ADDENDUM NUMBER ONE

**Liberty First Credit Union
North 84th Street & Lexington Avenue
Lincoln, Nebraska
Project #: 2011-20**

DATE OF ISSUE: October 1, 2011

Sheet C3.0 – Paving Plan

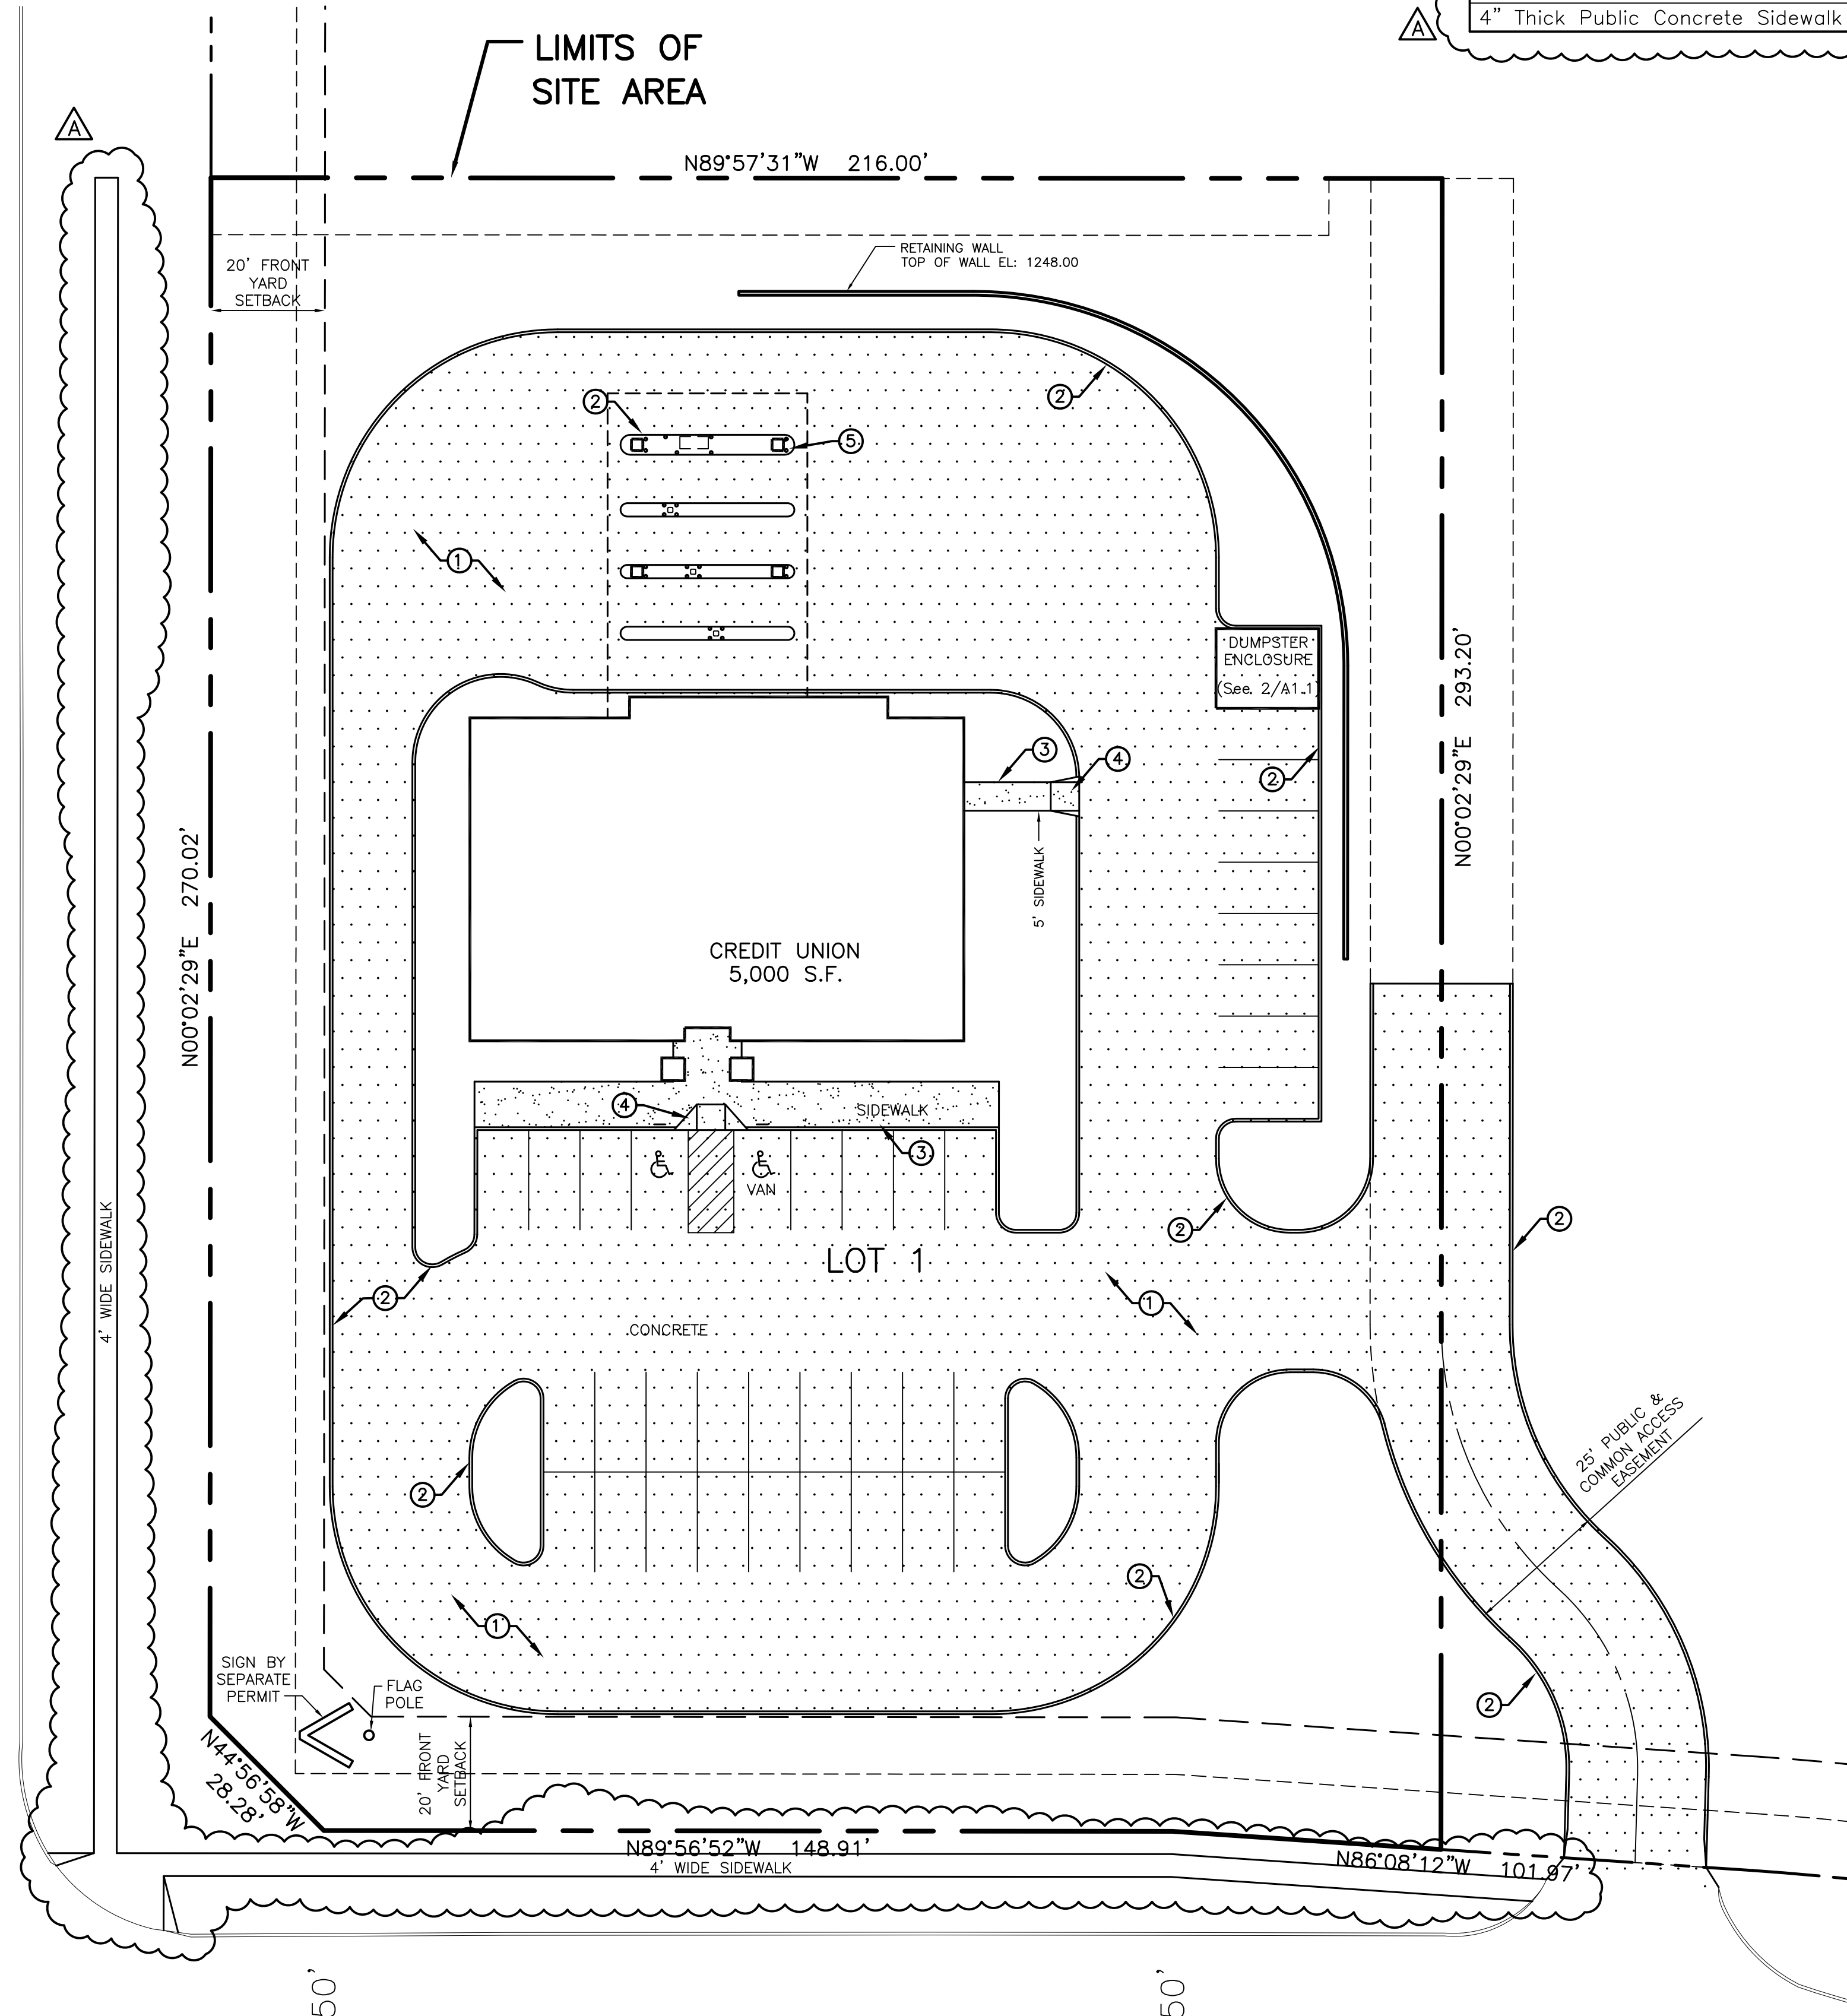
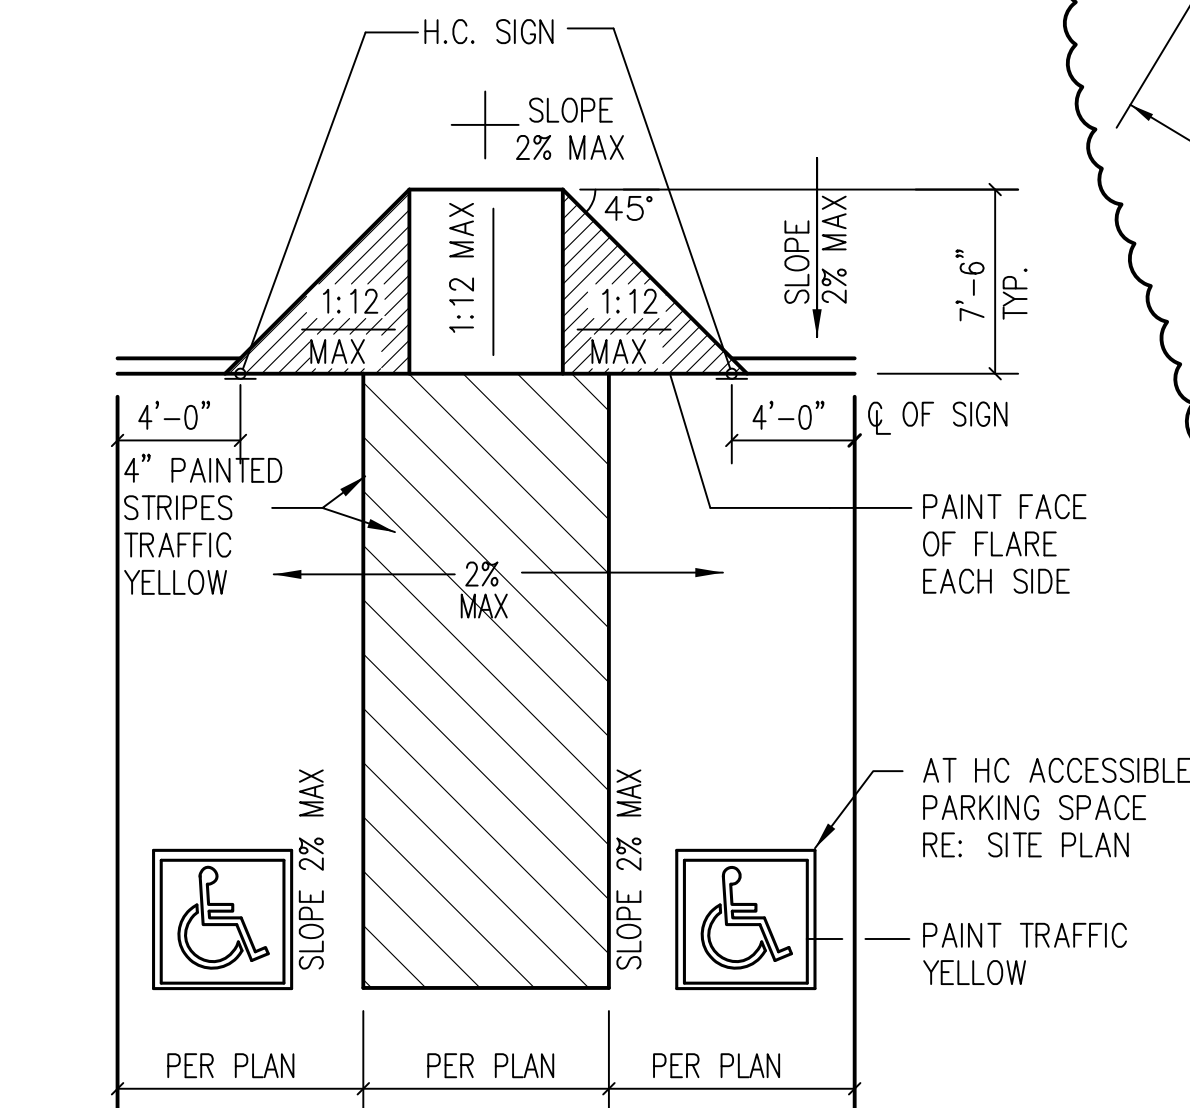
1. Revisions to walk along N 84th Street and Lexington Avenue and accessible curb ramp detail
See attached revised sheet C3.0
